# 802.1Qau Draft 1.0 Ballot Issues

**Version 1**

**Norman Finn**

- Fragment of Draft 1.0 Figure 31-2

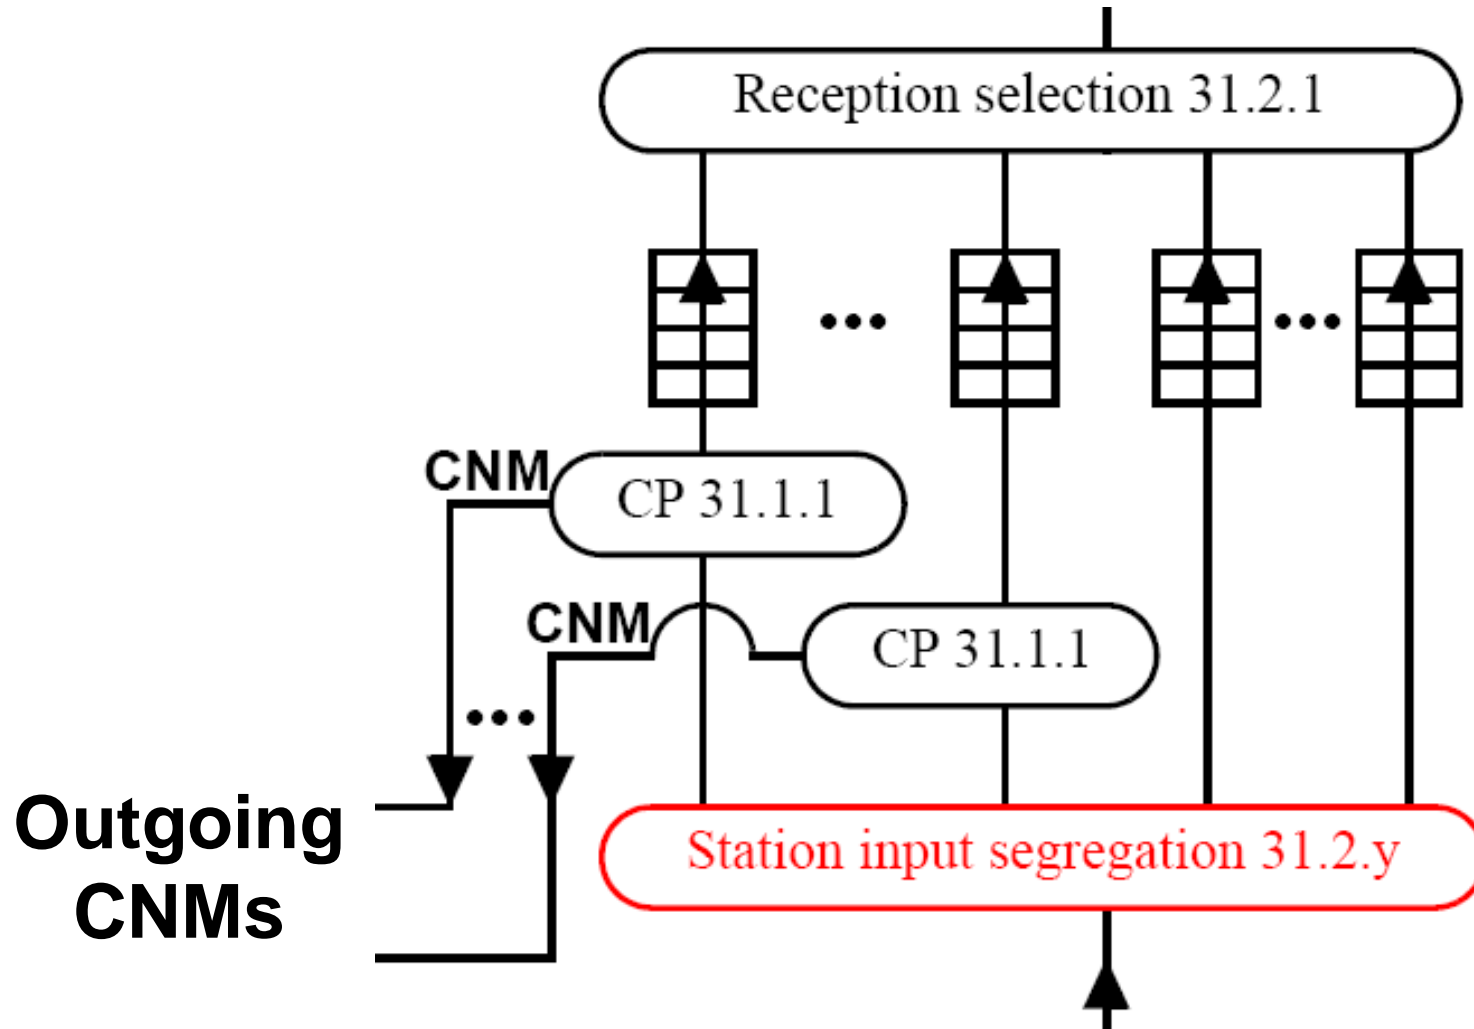
- In Draft 1.0, the end station must have the same per-priority queues and CPs that a Bridge must have.
- But, an end station may not need to issue CNMs based only on priority; it may have the ability to issue CNMs based on any other granularity, e.g. per-application.
- Therefore, we will not specify how the end station segregates traffic among CPs.

- In Draft 1.0, the end station must have the same per-priority queues and CPs that a Bridge must have.
- But, an end station may not need to issue CNMs based only on priority; it may have the ability to issue CNMs based on any other granularity, e.g. per-application.
- Therefore, we will not specify how the end station segregates traffic among CPs.

Figure 31-2—Congestion aware queue functions in a station

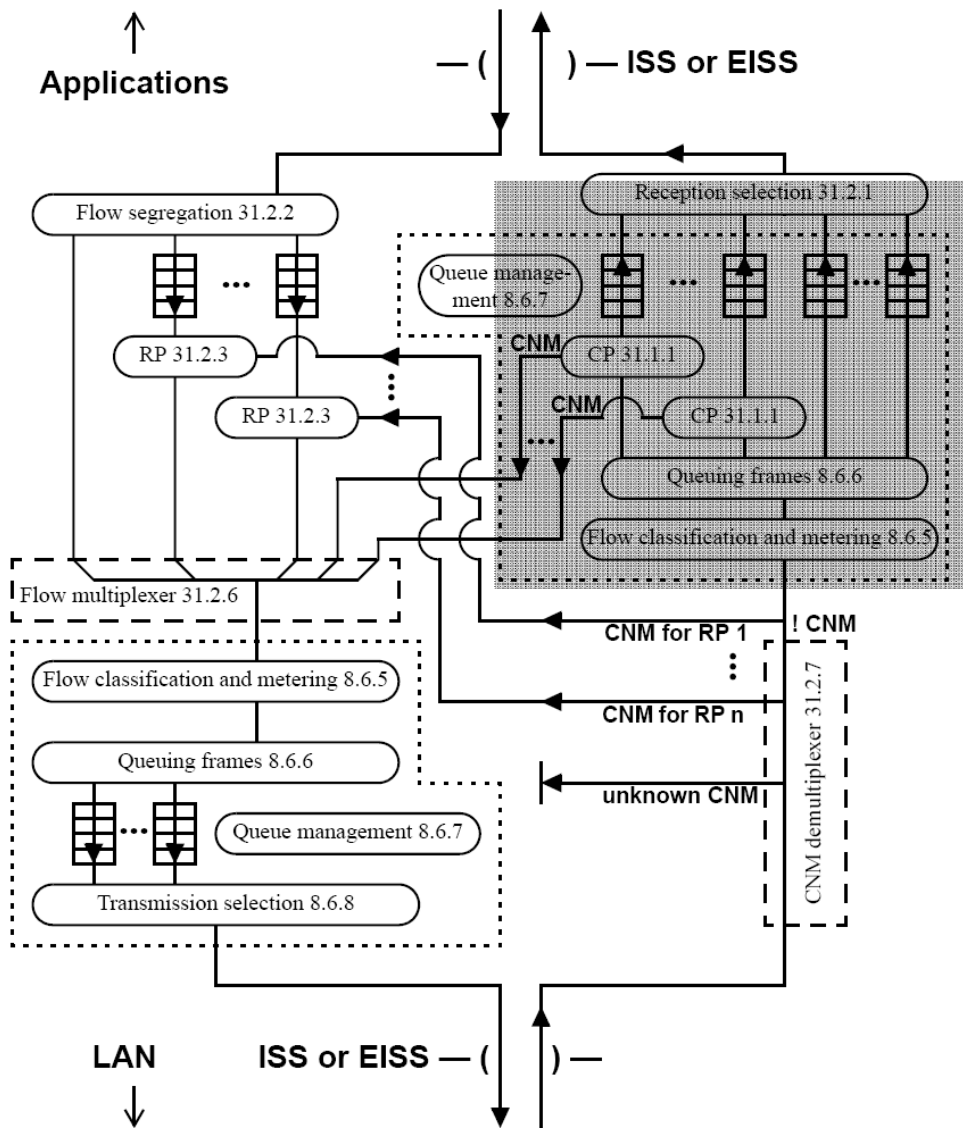
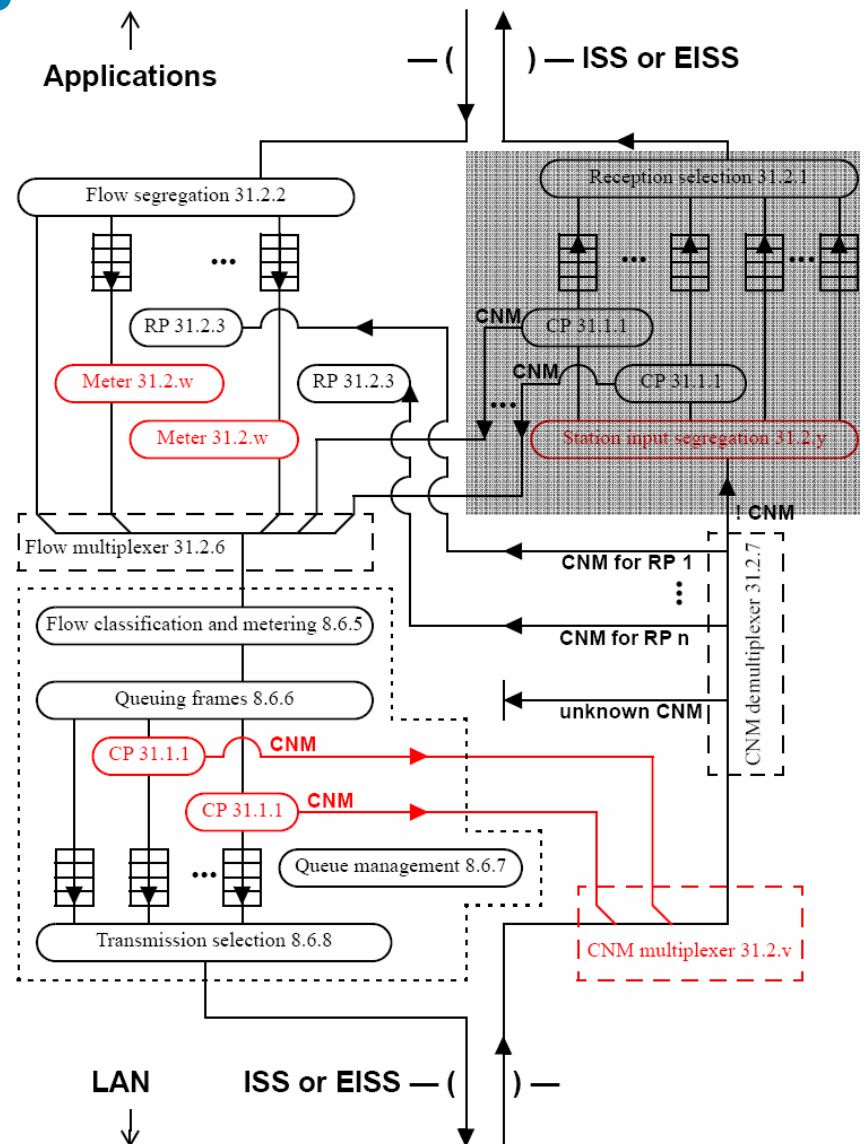
- In Draft 1.0, a Flow queue can have an attached RP.
  - The RP state machine determines the current flow rate.
  - But, there is no function specified to actually drain the queues at that flow rate.
- Therefore, we transmit CNMs internally, to prevent priority queue overflow.
- This may use a faster sampling rate (e.g., 25% instead of 1%).
- From outside the box, it is impossible to tell whether the CNMs are actually generated.

Figure 31-2—Congestion aware queue functions in a station

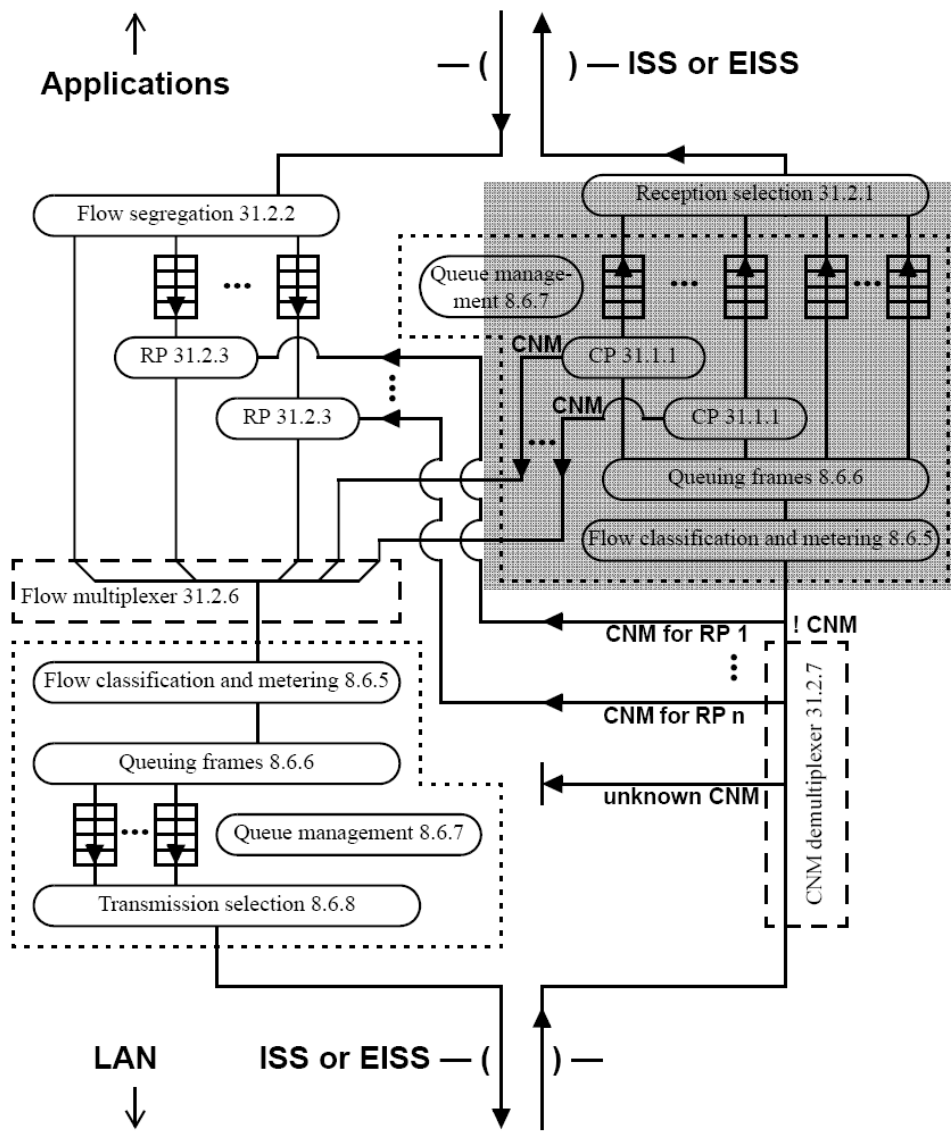
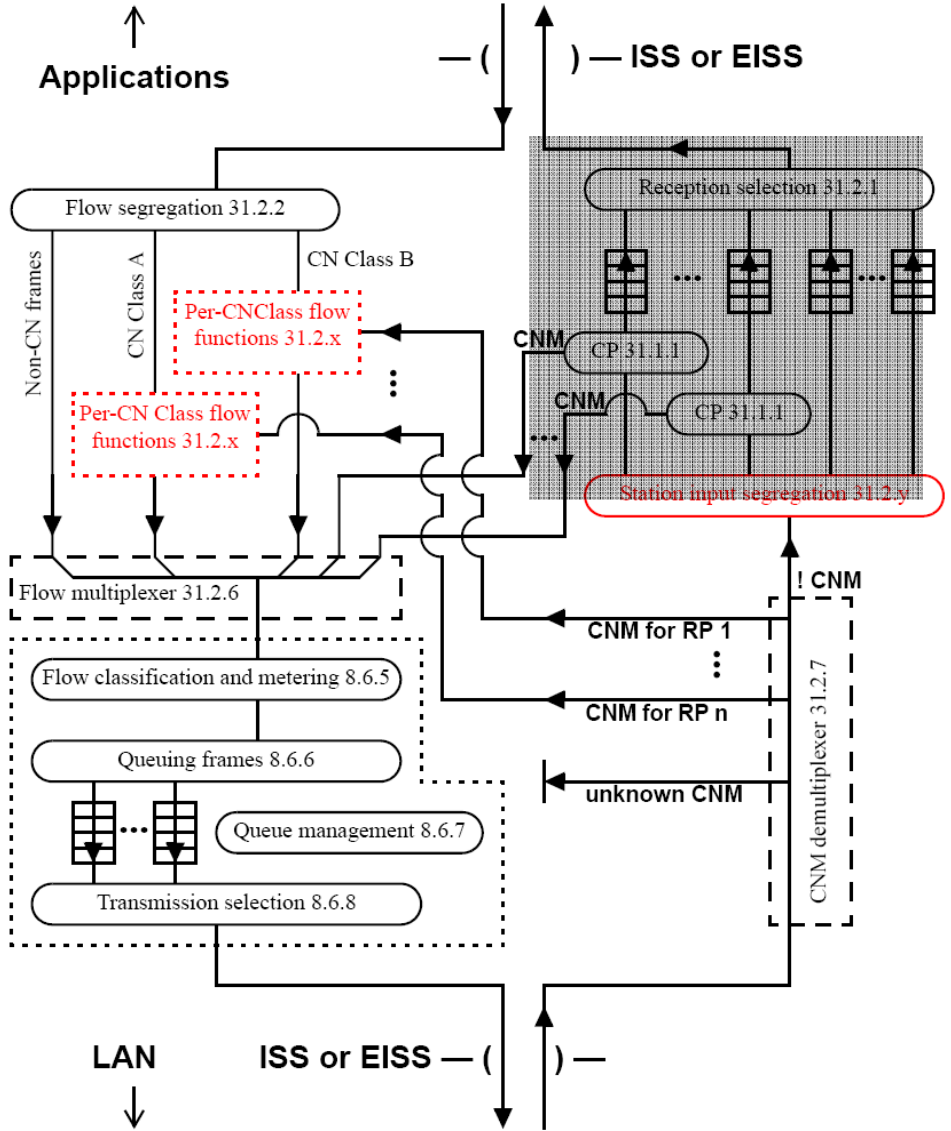
- Do we do:

Choice 1 (Internal CNMs); or

Choice 2 (Disconnect actual transmit rate from RP transmit rate).

- Fragment of Draft 1.0 Figure 31-2

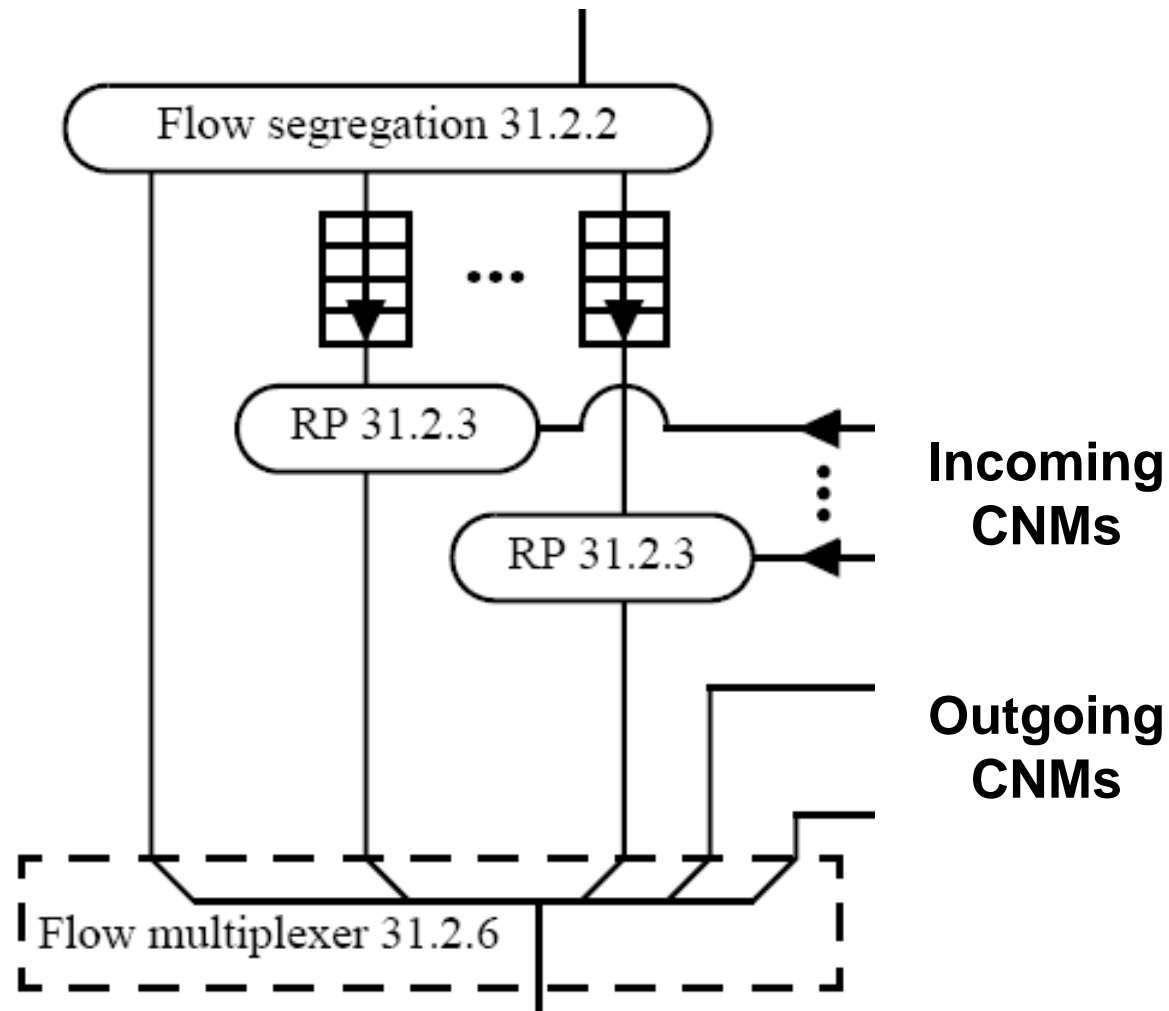
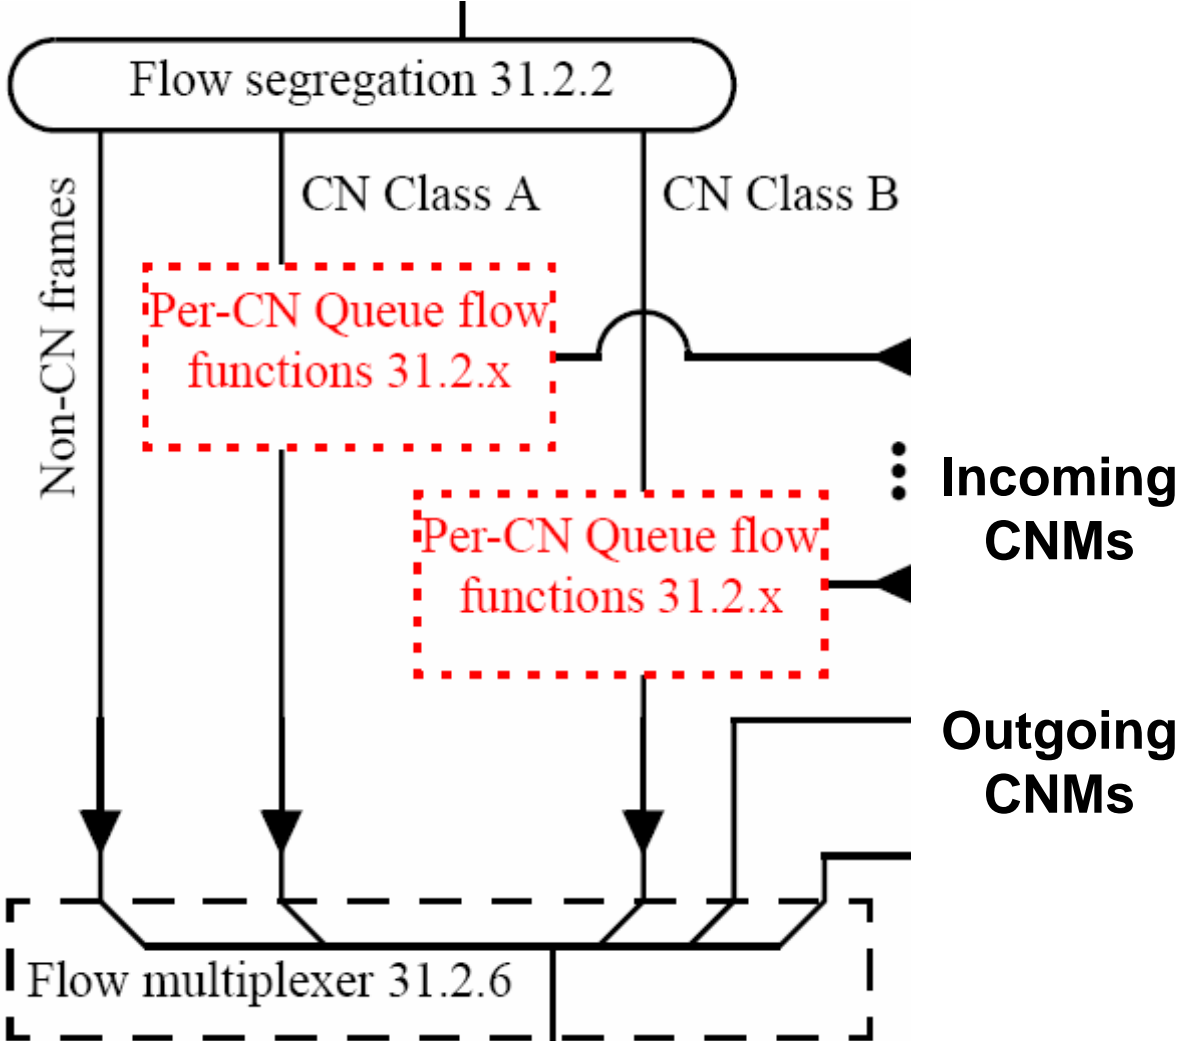
- In Draft 1.0, a Flow queue can have an attached RP.

The RP state machine determines the current flow rate.

But, there is no function specified to actually drain the queues at that flow rate.

- Therefore, we split the RP functions up by CN queue, one Per-CN queue function per CN priority queue.

Figure 31-3—Per-CN queue flow functions in a station

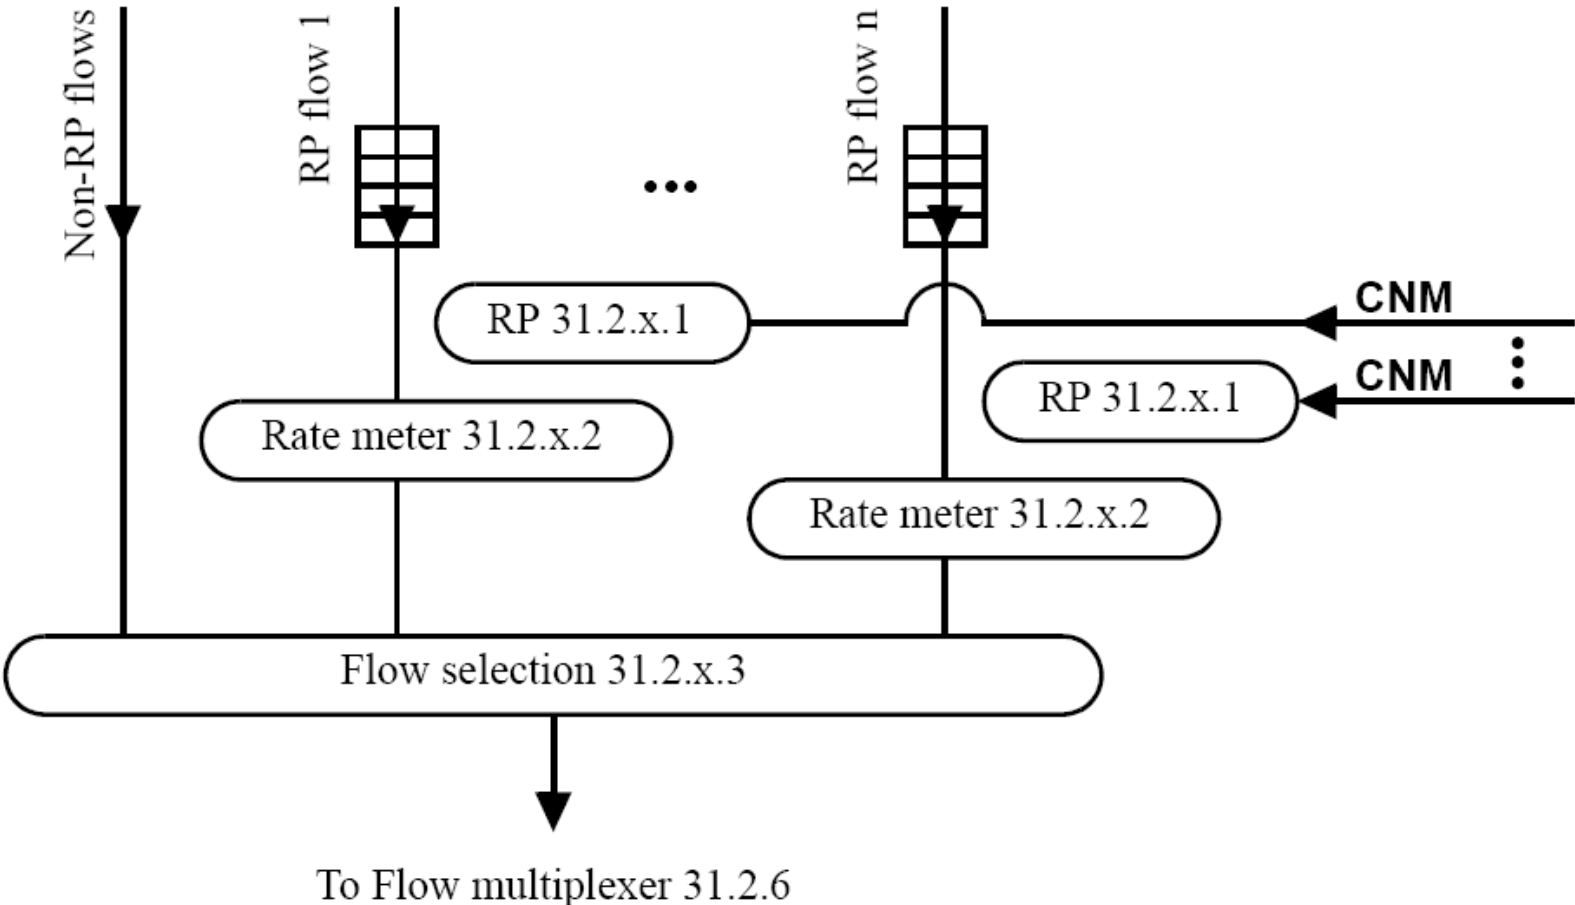
- Non-CN traffic bypasses the Per-CN Queue flow functions.
- There is one Per-CN Queue flow function for each CN priority queue.
- More than one CN Class can be directed to the same priority queue.

- Rate Meter offers frames to lower layers at the rate specified by the RP.
- If it is time to offer a new frame, but the old frame has not yet been taken, then the transmit rate clock freezes until the old frame is taken, and the new frame becomes the old frame.

- The Flow selection function never takes a frame if its corresponding CN priority queue has more than one frame in it.
- Flow selection takes frames in the following order:

Frames not controlled by an RP are taken first.

If there are no frames that are not controlled by an RP, the controlled frames are taken in proportion to the RPs' current transmit rates.
